SERVICE BULLETIN

N° **139-694**

ATA 56 – WINDOW GASKET UPGRADE

This Service Bulletin is issued in order to provide the necessary instructions to introduce a new gasket installation on the basic jettisonable emergency exit of the helicopter .

Figure 8

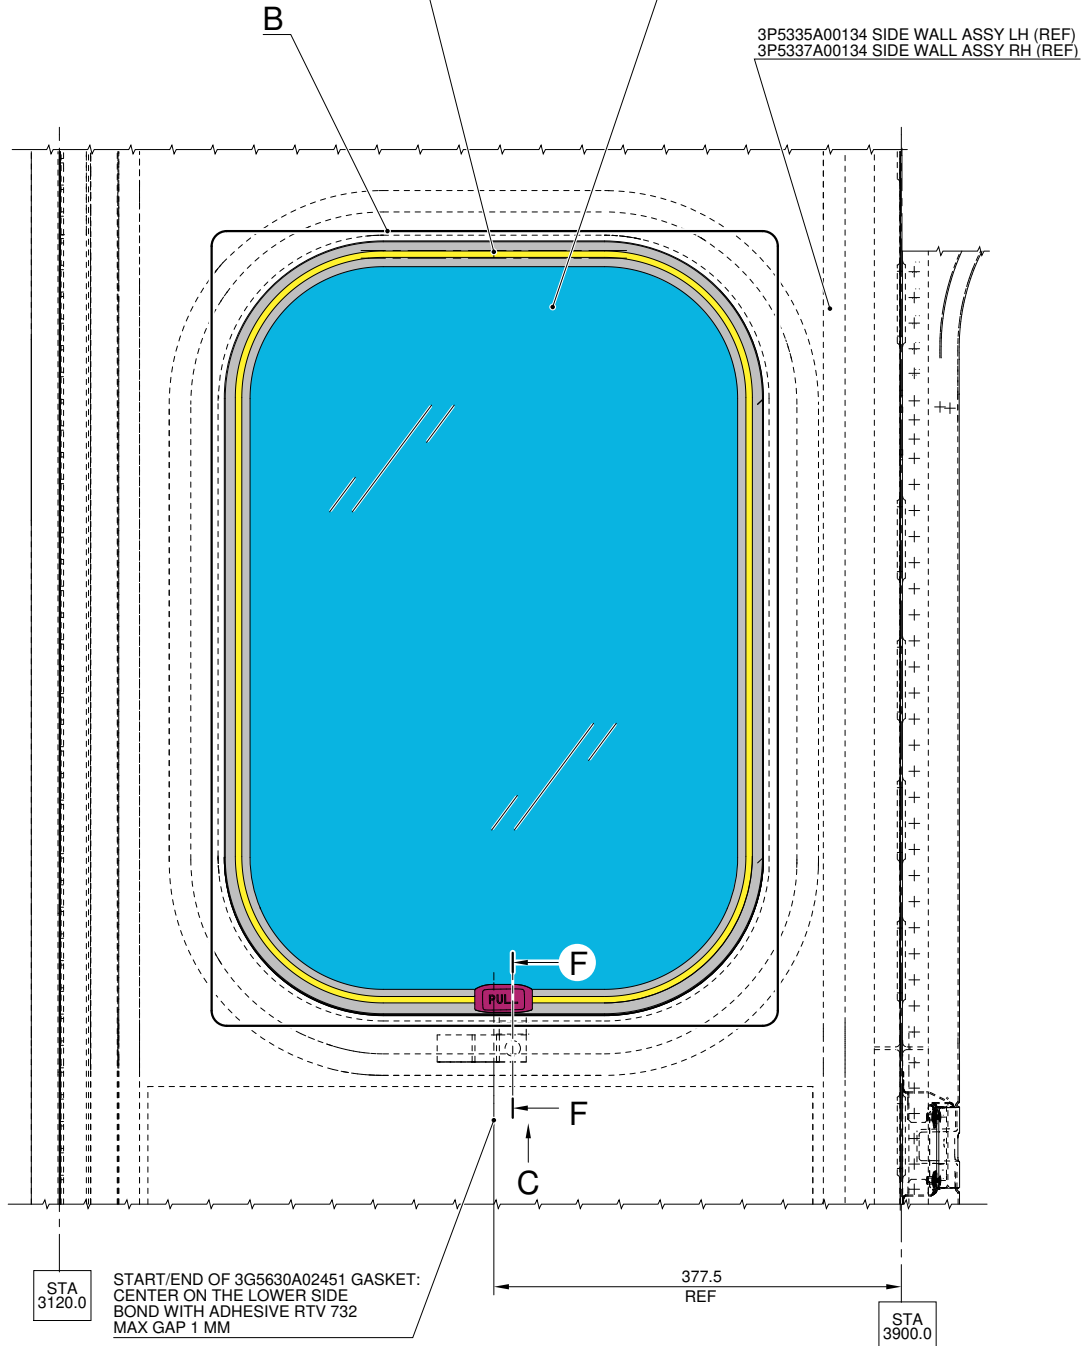
2. In accordance with the applicable steps of AMP DM 39-A-56-21-01-00A-920A-A and with reference to Figures 7 and 8 Detail A, from the left side wall assy, remove the existing window panel (retain for later reuse), extd rubber window seal P/N A417AG002WB, n°2 extd rubber fillers P/N A417AF001WB, strap assembly P/N A487A005A and stud P/N MS27980-13N.

⚠ THE WINDOW PANEL MAY BE SLIGHTLY DIFFERENT FROM THAT SHOWN.

REMOVE:
 ① 3P5330A18951 WINDOW PANEL
 A417AG002WB EXT. RUBBER WINDOW SEAL
 A417AF001WB EXT. RUBBER FILLER (2 OFF)
 A487A005A STRAP ASSEMBLY
 MS27980-13N STUD

8.1 In accordance with the applicable steps of AMP DM 39-A-56-21-01-00A-920A-A and with reference to Figures 8 thru 10, install the following components on the left side wall assy:

Figure 10

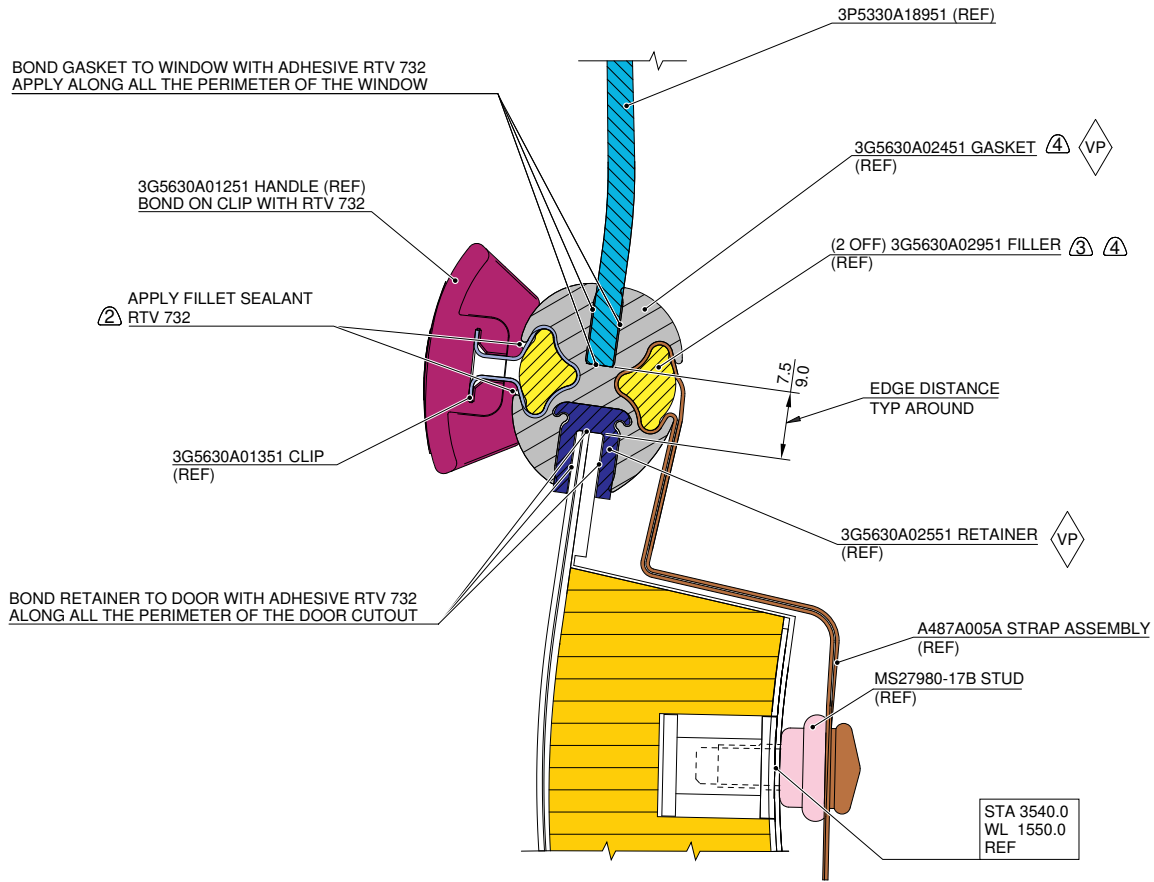
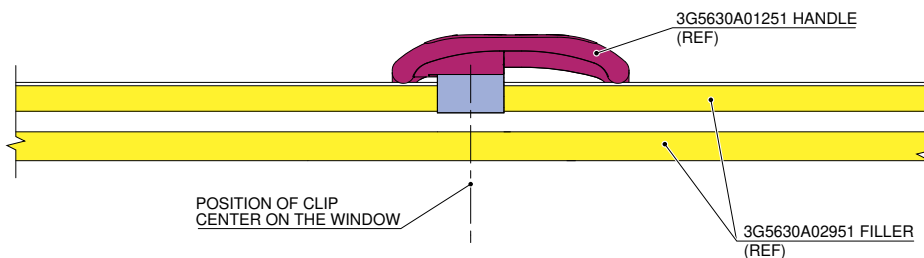
- ② APPLY THE FILLET SEALANT ONLY AFTER INSTALLING THE CLIP P/N 3G5630A01351 AND FILLER (P/N 3G5630A02351 AND P/N 3G5630A02951) IN THE GASKET SEAT. THE FILLET SEALANT MUST BE AS LONG AS THE CLIP TO PREVENT THE SQUEEZE OUT GOING ON FILLER INSIDE THE GASKET SEAT.
- ③ ON INTERNAL FUSELAGE SIDE INSTALL FILLER STARTING FROM TOP SIDE OF FRAME WINDOW.
- ④ ON EXTERNAL FUSELAGE SIDE:
 - INSTALL FILLER STARTING FROM TOP SIDE OF FRAME WINDOW;
 - CHECK IF THERE IS SQUEEZE OUT OF ADHESIVE ALL AROUND THE GASKET,IF NOT, LIFT THE SEAL EDGE AND FILL AGAIN.

Figure 15

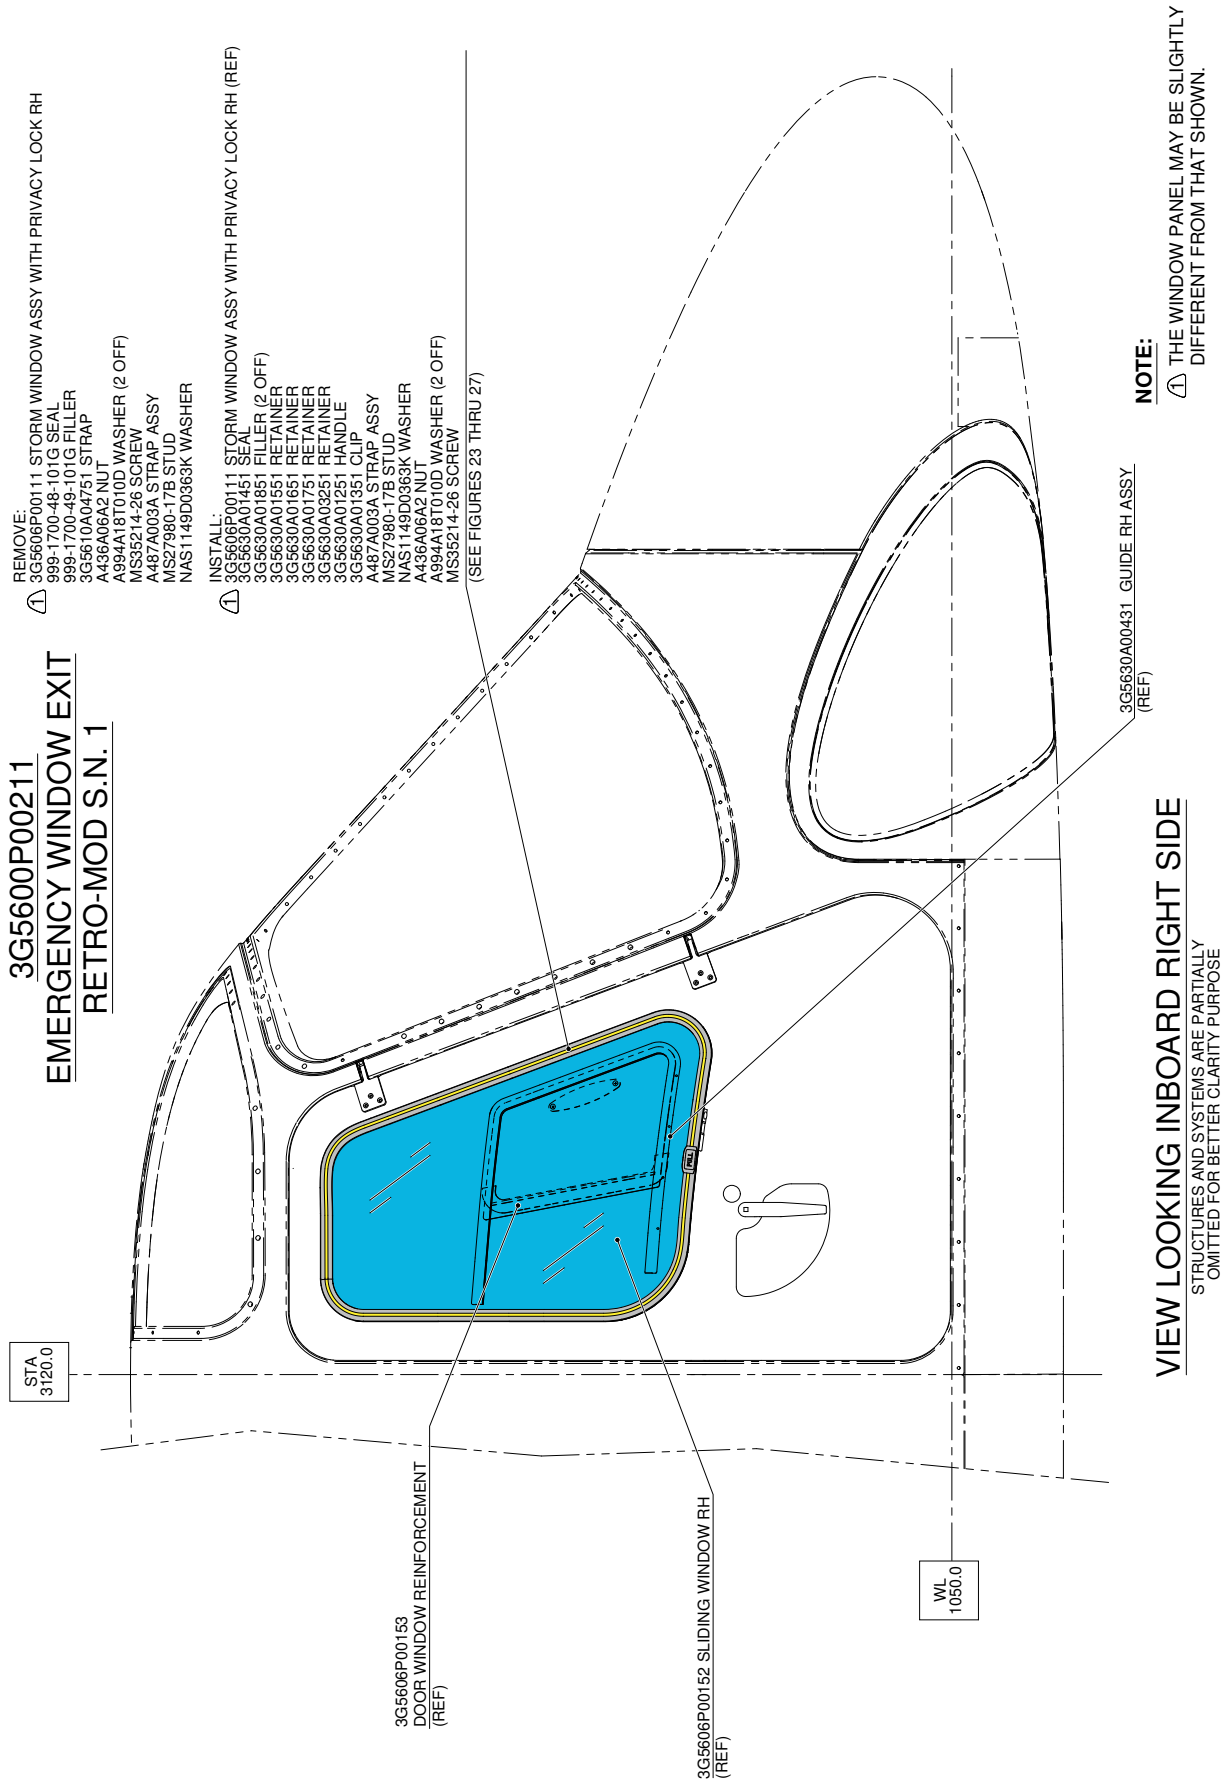
For the emergency exit window retromod P/N 3G5600P00211 refer to Figure 15 and Figures 23 thru 27.

2. In accordance with the applicable steps of AMP DM 39-B-56-31-01-00A-920A-K and with reference to Figures 15 or 16 or 17 or 18 or 19 or 20 or 21 or 22, remove the following components from the left cockpit door:

Figure 16

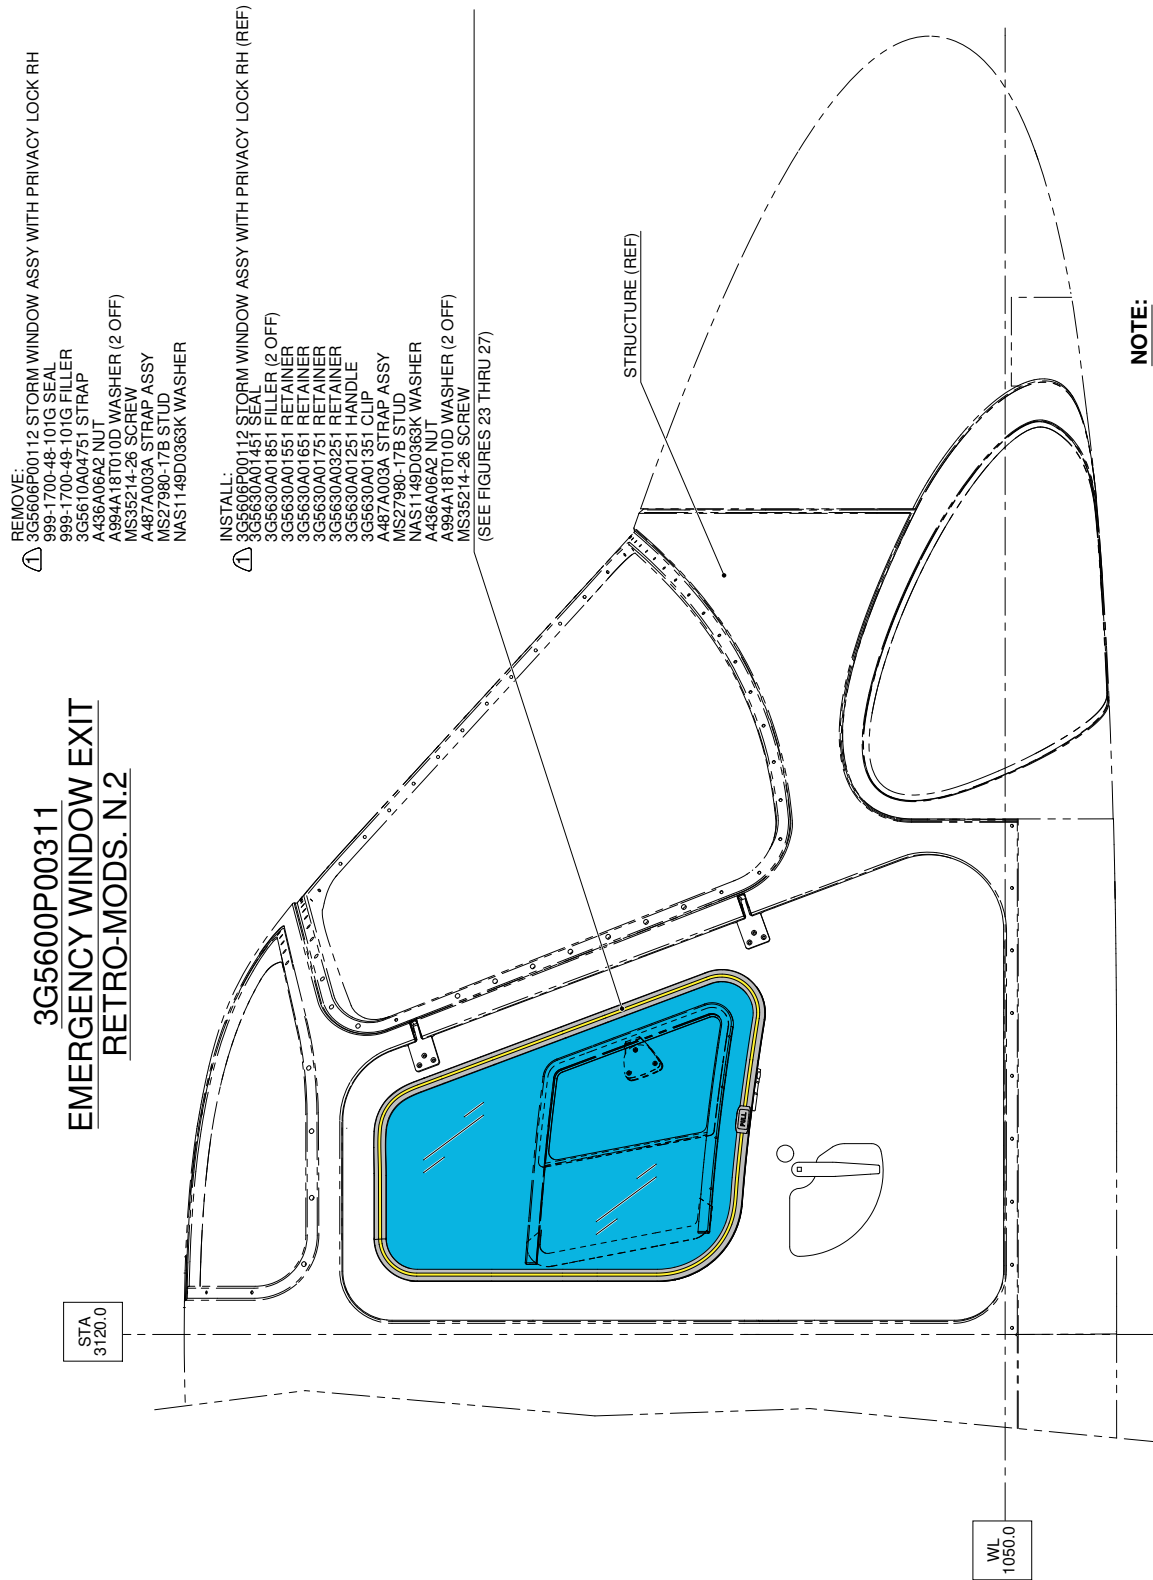
For the emergency exit window retromod P/N 3G5600P00311 refer to Figure 16 and Figures 23 thru 27.

Figure 17

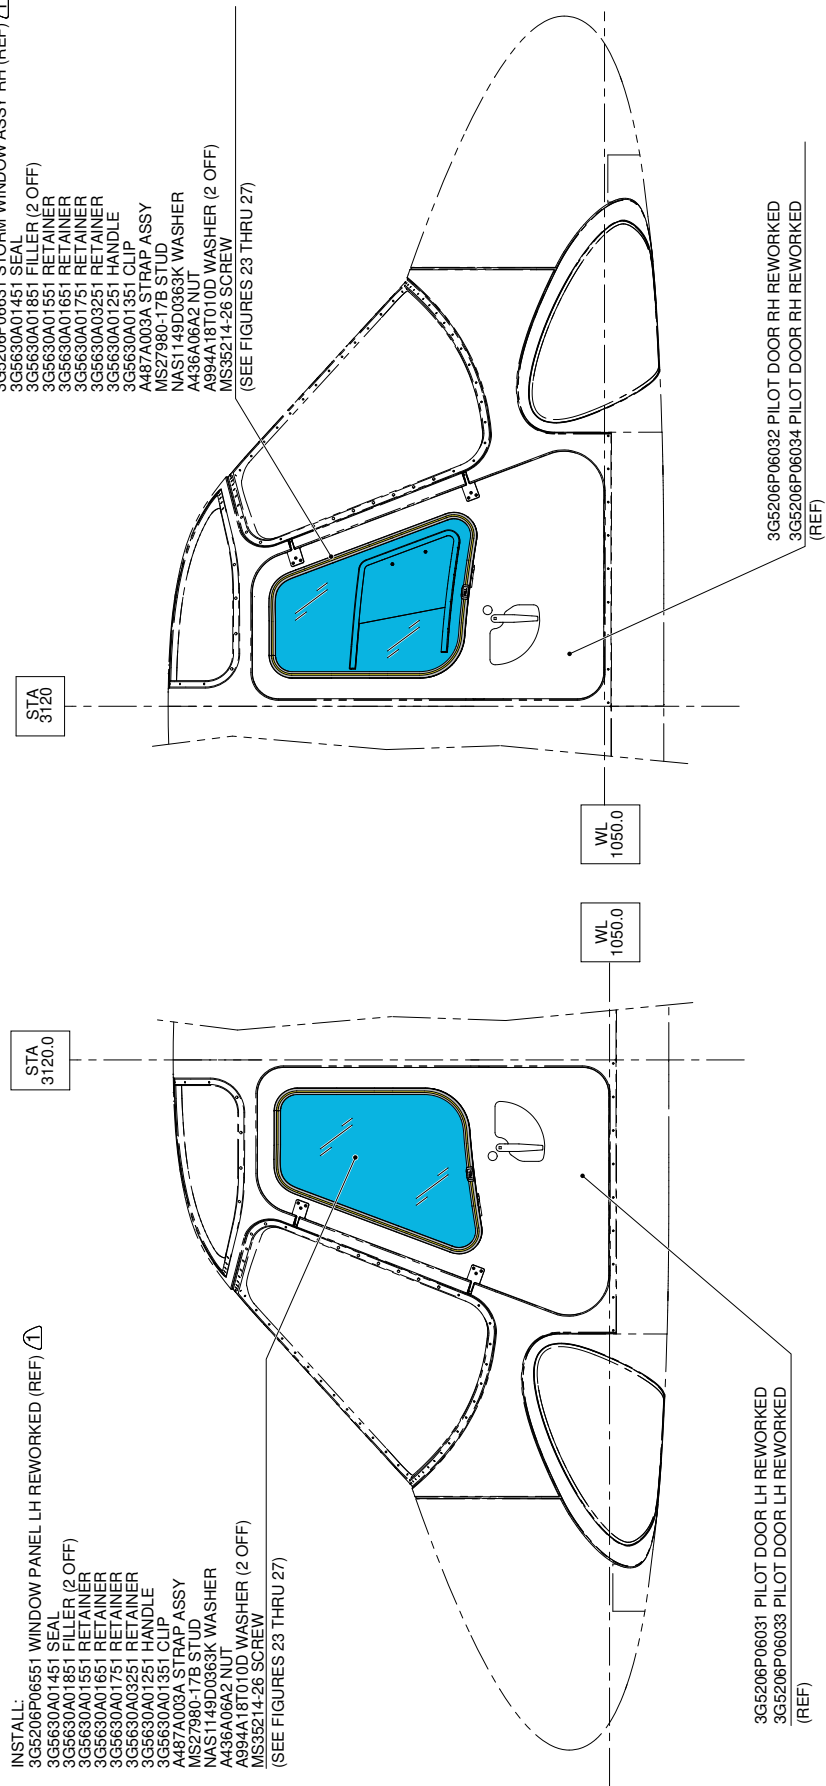
REMOVE:
3G5206P06631 STORM WINDOW ASSY RH (REF) 
989-1700-48-101G SEAL
989-1700-49-101G FILLER
3G5610A04751 STRAP
A436A06A2 NUT
A994A18T010D WASHER (2 OFF)
MS35214-26 SCREW
A487A003A STRAP ASSY
MSZ7980-17B STUD
NAS1149D0363K WASHER

INSTALL:
3G5206P06631 STORM WINDOW ASSY RH (REF) 
3G5630A01451 SEAL
3G5630A01851 FILLER (2 OFF)
3G5630A01551 RETAINER
3G5630A01651 RETAINER
3G5630A01751 RETAINER
3G5630A03251 RETAINER
3G5630A01251 HANDLE
3G5630A01351 CLIP
A487A003A STRAP ASSY
MSZ7980-17B STUD
NAS1149D0363K WASHER
A436A06A2 NUT
A994A18T010D WASHER (2 OFF)
MS35214-26 SCREW
(SEE FIGURES 23 THRU 27)

REMOVE:
3G5206P06551 WINDOW PANEL LH REWORKED 
989-1700-48-101G SEAL
989-1700-49-101G FILLER
3G5610A04751 STRAP
A436A06A2 NUT
A994A18T010D WASHER (2 OFF)
MS35214-26 SCREW
A487A003A STRAP ASSY
MSZ7980-17B STUD
NAS1149D0363K WASHER

Figure 18

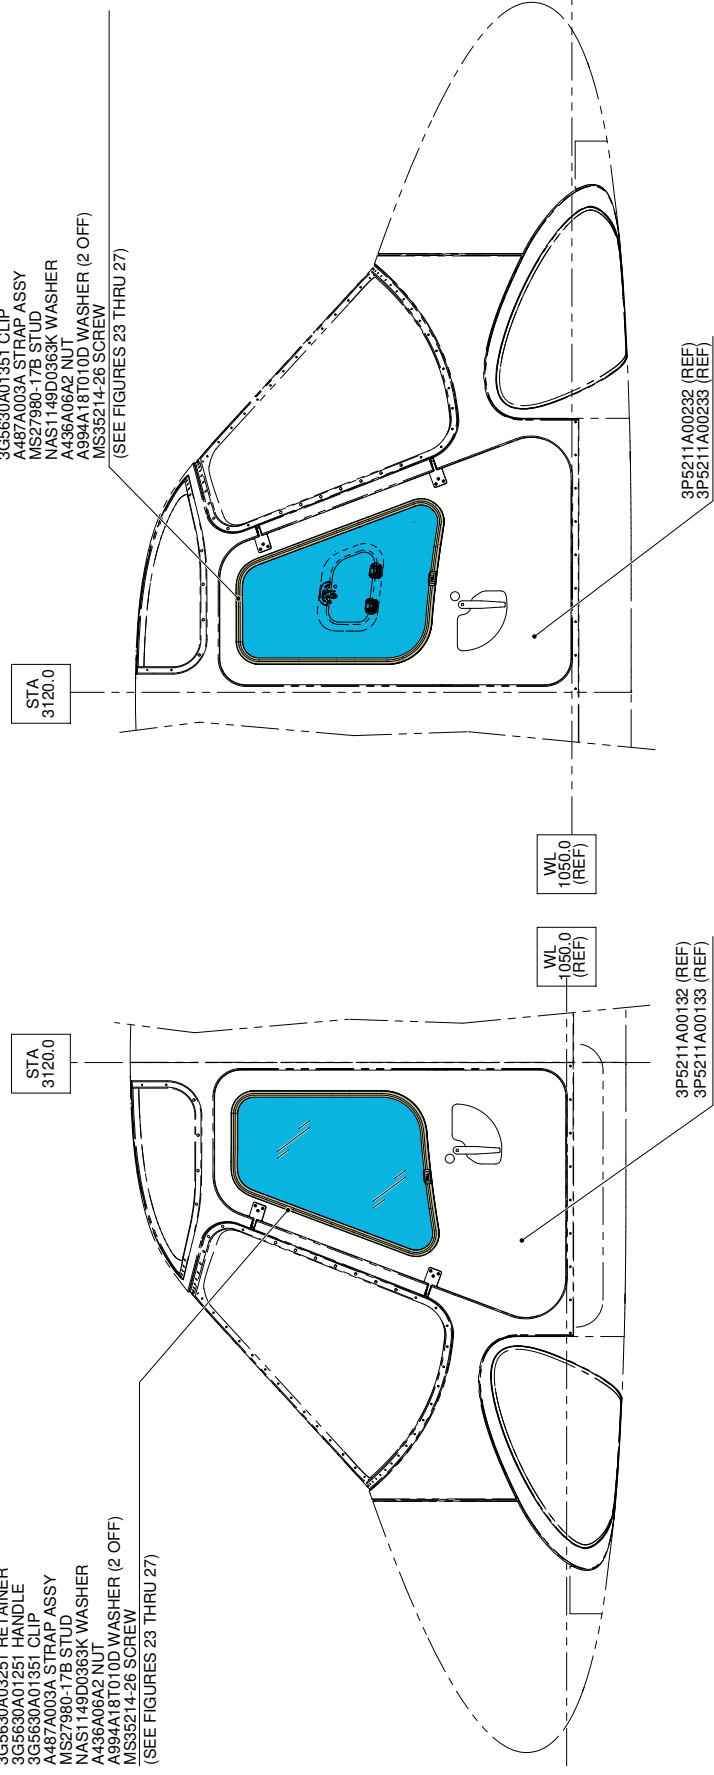
- REMOVE:**
 3G5211A00831 HINGED STORM WINDOW ASSY RH (REF) ⚠
 999-1700-48-101G SEAL
 999-1700-49-101G FILLER
 3G5610A04751 STRAP
 A436A06A2 NUT
 A994A18T010D WASHER (2 OFF)
 MS35214-26 SCREW
 A487A003A STRAP ASSY
 MS27980-17B STUD
 NAS1149D0363K WASHER
- INSTALL:**
 3G5211A00831 HINGED STORM WINDOW ASSY RH (REF) ⚠
 3G5630A01451 SEAL
 3G5630A01851 FILLER (2 OFF)
 3G5630A01551 RETAINER
 3G5630A01751 RETAINER
 3G5630A03251 RETAINER
 3G5630A01351 HANDLE
 A487A003A STRAP ASSY
 MS27980-17B STUD
 NAS1149D0363K WASHER
 A436A06A2 NUT
 A994A18T010D WASHER (2 OFF)
 MS35214-26 SCREW
 (SEE FIGURES 23 THRU 27)

- REMOVE:**
 3G5211A01351 WINDOW PANEL LH REWORKED ⚠
 999-1700-48-101G SEAL
 999-1700-49-101G FILLER
 3G5610A04751 STRAP
 A436A06A2 NUT
 A994A18T010D WASHER (2 OFF)
 MS35214-26 SCREW
 A487A003A STRAP ASSY
 MS27980-17B STUD
 NAS1149D0363K WASHER
- INSTALL:**
 3G5211A01351 WINDOW PANEL LH REWORKED (REF) ⚠
 3G5630A01451 SEAL
 3G5630A01851 FILLER (2 OFF)
 3G5630A01551 RETAINER
 3G5630A01751 RETAINER
 3G5630A03251 RETAINER
 3G5630A01351 HANDLE
 A487A003A STRAP ASSY
 MS27980-17B STUD
 NAS1149D0363K WASHER
 A436A06A2 NUT
 A994A18T010D WASHER (2 OFF)
 MS35214-26 SCREW
 (SEE FIGURES 23 THRU 27)
